Class 1 Permit Modification Notification
Install Bulkheads in Underground Waste Disposal Rooms

**Waste Isolation Pilot Plant
Carlsbad, New Mexico**

Permit Number-NM4890139088-TSDF

December 2009

Figure M2-11a
Typical Bulkhead

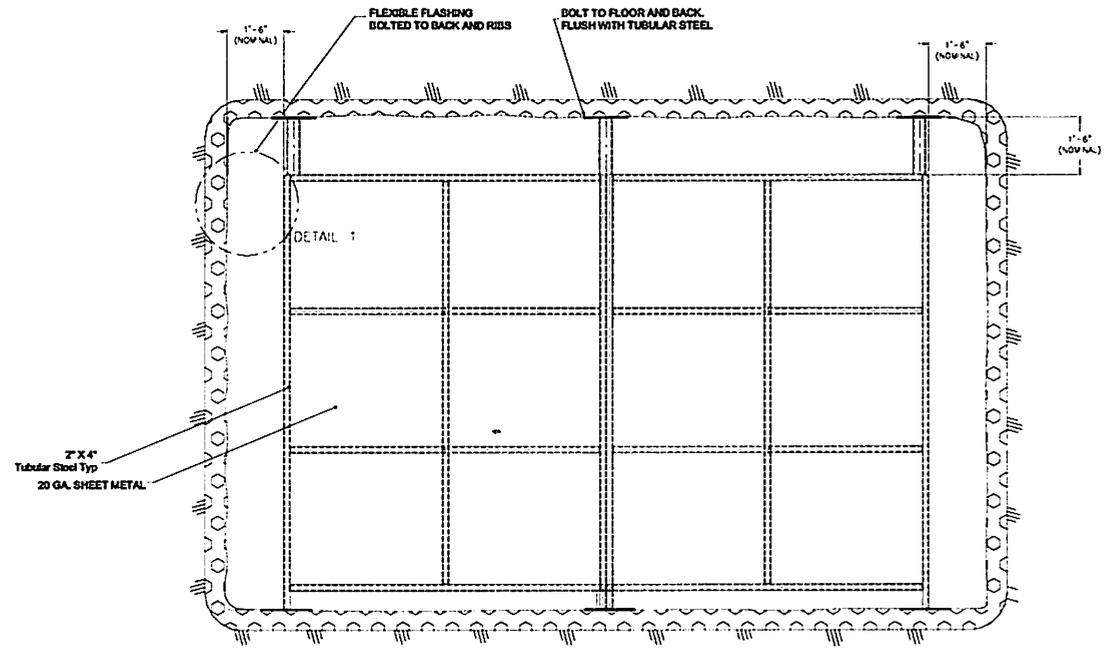
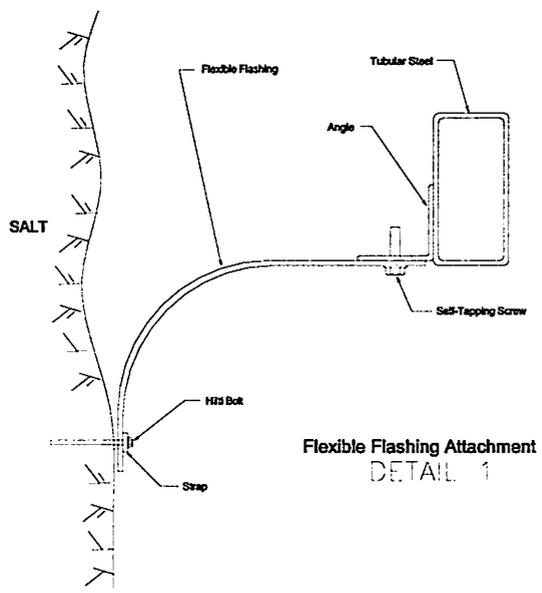
This change will allow for the installation of a typical WIPP bulkhead in addition to the existing chain link and brattice cloth should additional ventilation control be required. For example, additional ventilation control may serve to reduce emissions of VOCs from filled rooms in active panels. No reduction in the existing ventilation requirements is requested. Sections M2-2a(3) and M2-2b are being revised. A new figure showing a typical bulkhead is being added as Figure M2-11a.

Once a disposal room is filled and is no longer needed for emplacement activities, it will be barricaded against entry and isolated from the mine ventilation system by removing the air regulator bulkhead and constructing chain link/brattice cloth barricades and, if necessary, bulkheads at each end. A typical bulkhead is shown in Figure M2-11a. There is no requirement for air for these rooms since personnel and/or equipment will not be in these areas.
